IDAP REPORT

Property:	21 Long Street, Strathfield LOT 3 DP 755 DA2022.75
Proposal:	Demolition of existing structures and construction of a new two (2) storey dwelling with basement
Applicant:	Buildcraft Group Pty Ltd
Owner:	Mrs Katelyn Lee
Date of lodgement:	21 April 2022
Notification period:	10 May 2022 – 24 May 2022
Submissions received:	1
Assessment officer:	W van Wyk
Estimated cost of works:	\$1,779,231.00
Zoning:	R2 Low Density Residential - SLEP 2012
Heritage:	No
Flood affected:	Yes
Is a Clause 4.6 Variation proposed:	No
RECOMMENDATION OF OFFICER:	APPROVAL

Figure 14: Second Floor Level with Void Highlighted

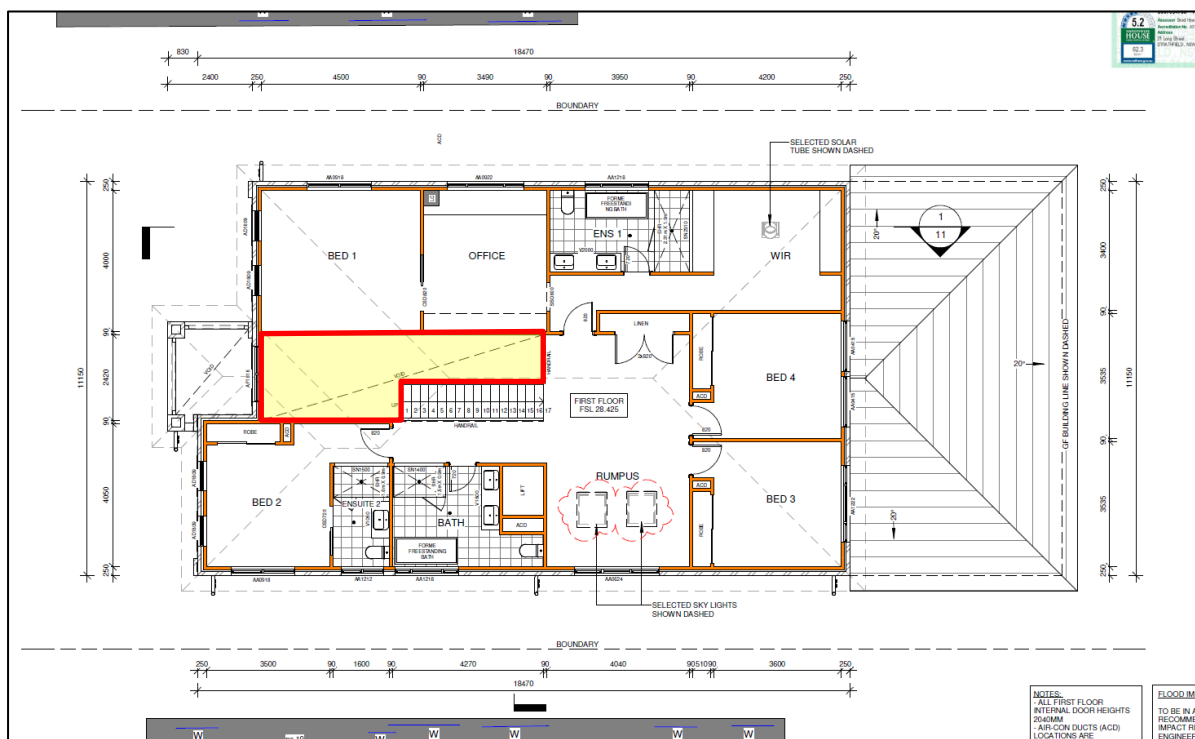
The proposal generally provides 2.72m floor to ceiling heights which easily comply with the 3m maximum control. However, the void above the foyer and stairway does not comply (see **Figure 14**). The void area is only approximately 15m² which is considered reasonable. As it is centrally located, it will not result in overshadowing impacts on surrounding sites and contributes to a consistent architectural appearance. The proposal remains within a compliant building envelope. Accordingly, the minor non-compliance is considered reasonable in the circumstances.

Figure 15: Proposed Front Fencing

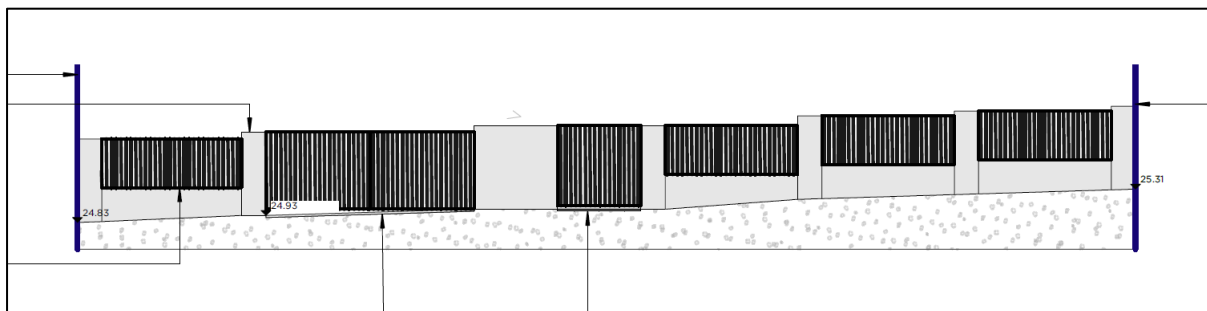
The proposed front fence will be a maximum of 1.2m which easily complies with the 1.5m SCDP 2005 provision. There will be a 0.5m solid dwarf wall with 0.7m aluminium piers above. There will be 0.3m wide rendered masonry piers at regular intervals with a wider 1.2m component next to the driveway gates (see **Figure 15**). These solid components are anticipated by the SCDP 2005 which states:

Brick piers over 1m in height are permitted to support the decorative elements, provided they are equally spaced along the street and do not exceed a height of 1.5m. Where the predominant height of fencing in the street is higher, the solid fence component shall not exceed a height of 1m.

However as these elements extend to 1.2m, they exceed the 1m height provision. This is a minor exceedance with creates greater consistency in the fence appearance. The fence will continue to satisfy the relevant objectives within the SCDP 2005. It is considered to be sympathetic to the existing and desired character of the locality and is compatible to the height and style of adjoining fences. Accordingly, the minor exceedance is supported in this instance.

Figure 16: Section showing raised alfresco

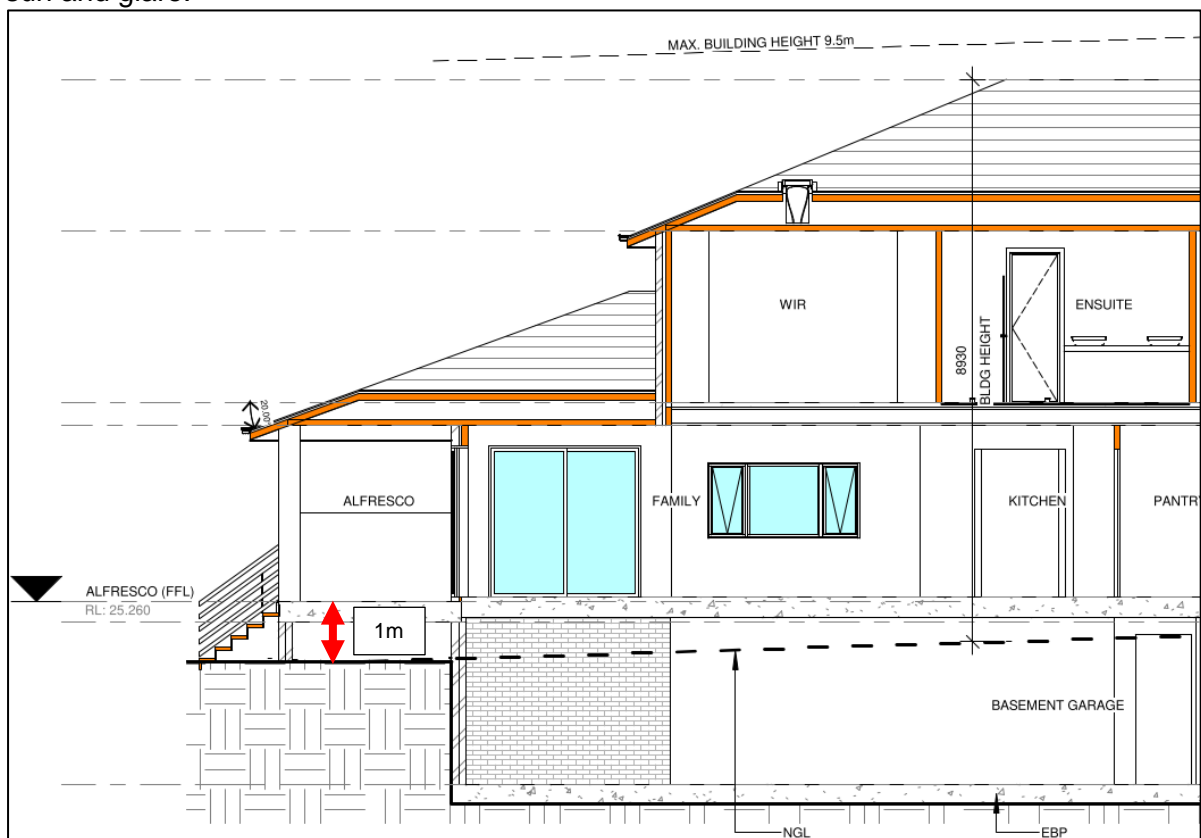
The only potential significant privacy impact will be from the raised alfresco area at the rear which could facilitate sightlines into the adjoining properties. The floor level of this area is at RL 25.26 while the top of the side boundary fence appears in the order of RL 26.00. Given the alfresco area is proposed to be covered, it is likely to be utilised frequently. The ground of the alfresco area is raised 1m above the existing ground level (see **Figure 16**). To provide a balance between privacy and access from the living area, this area will be conditioned 500mm lower to RL 24.76 in accordance with Section 5.2.3(3) of the SCDP 2005.

As the area will remain raised, a condition of consent requiring a 1.8m privacy screen along the eastern and western boundaries of the alfresco area will be imposed to ameliorate this privacy impact. This is in accordance with Section 7.2.3(2) of the SCDP 2005. The occupants of the dwelling will benefit from the screening as it will provide some relief from the afternoon sun and glare.
